### Proposed Revisions to a Standard Plans Index

Index Number: 715-003

Sheet Number (s): 3

Index Title: UTILITY CONFLICT POLE

**FOUNDATION AND BASE DETAILS**

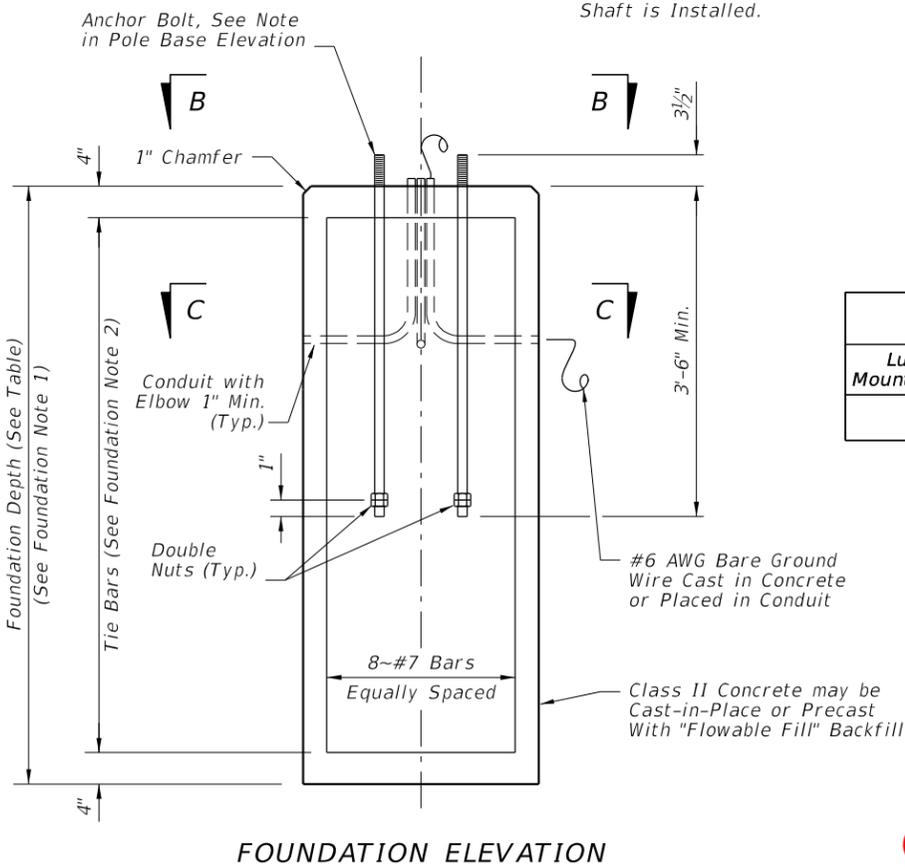
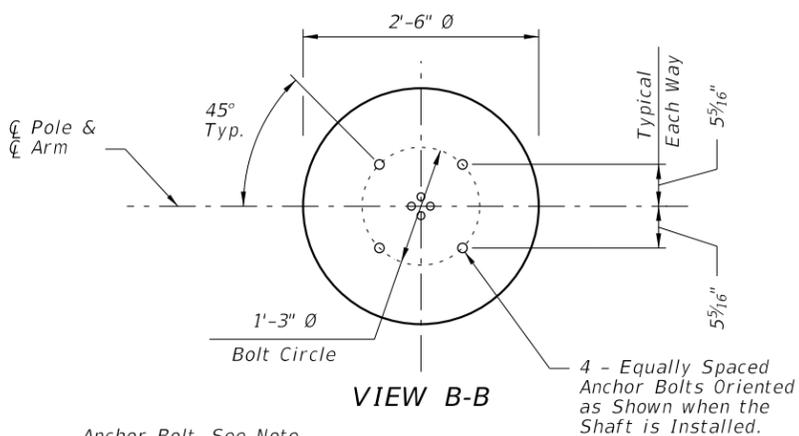
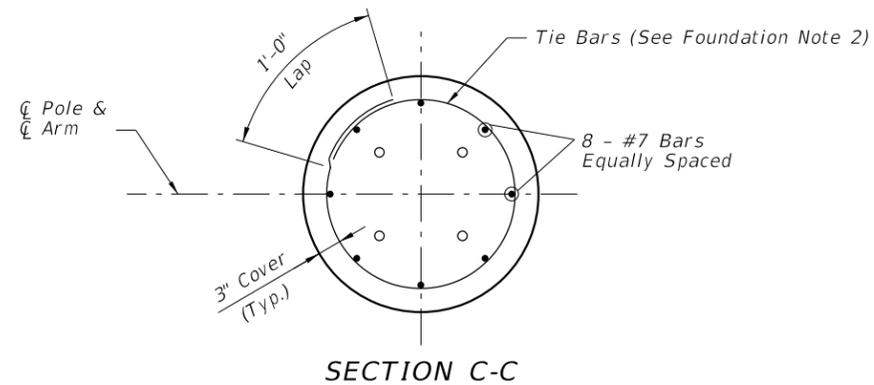
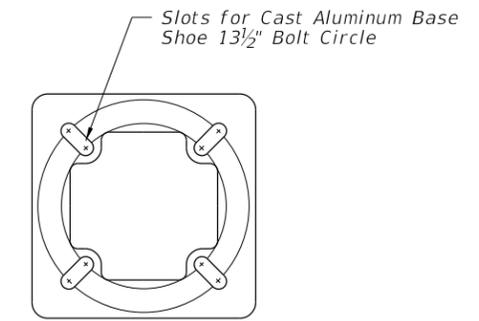
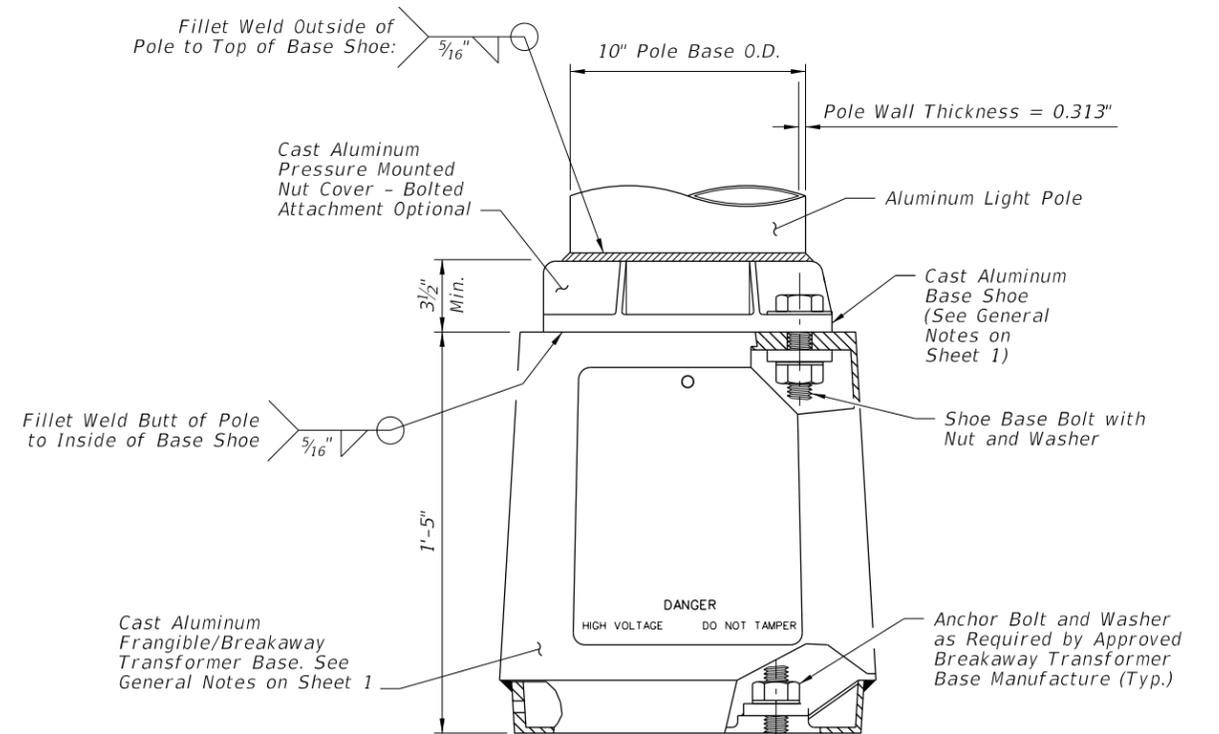
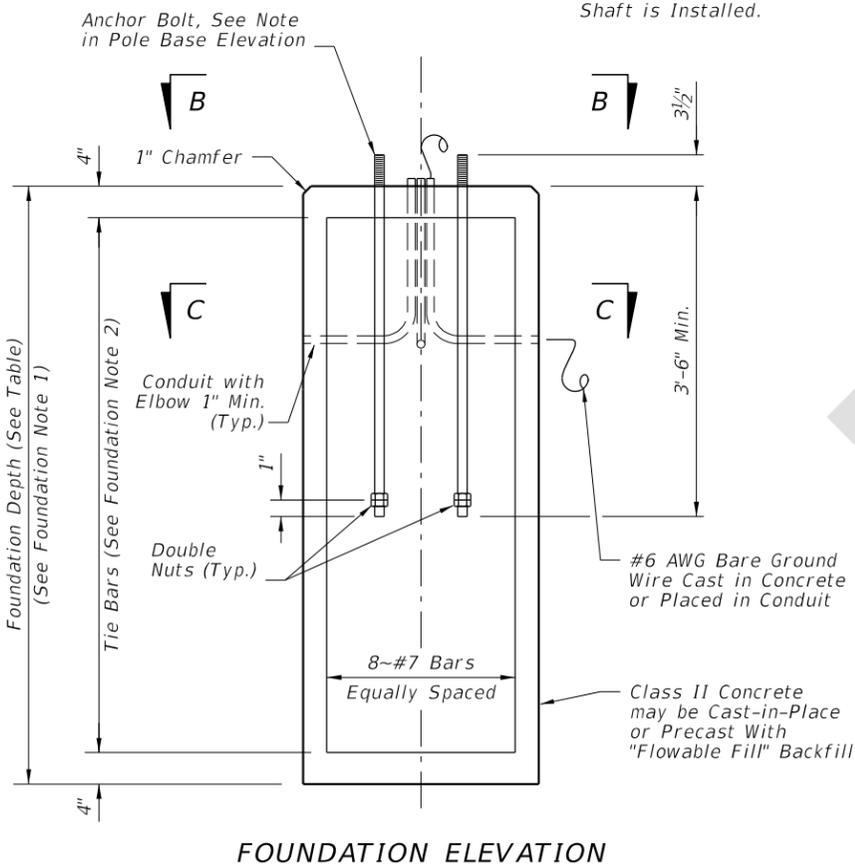
Sheet 3: Added Foundation Note 3 to allow for precast foundation with an octagon shape as a substitute for the circular shaped foundation shown.

Sheet 3: A non-circular, octagon shaft foundation option was requested by industry to simplify formwork.

Added Note 3 for Precast Octagon Shaped Foundation Option

1. Depths shown are for slopes equal to or flatter than 1:4. For slopes steeper than 1:4 and equal to or flatter than 1:2 add 2'-6" to foundation depths shown.
2. Foundation Tie Bars: #4 Tie Bars @ 12" centers (max.) or D10 (or W10) spiral @ 6" pitch, 3 flat turns top and 1 flat turn bottom.
3. For precast foundations, the circular cross section shown may be substituted with an octagon shape. The out-to-out distance between parallel edges of the octagon must be ≥ 2'-6". Use the same reinforcing diameter and centered placement with a minimum 3" cover.
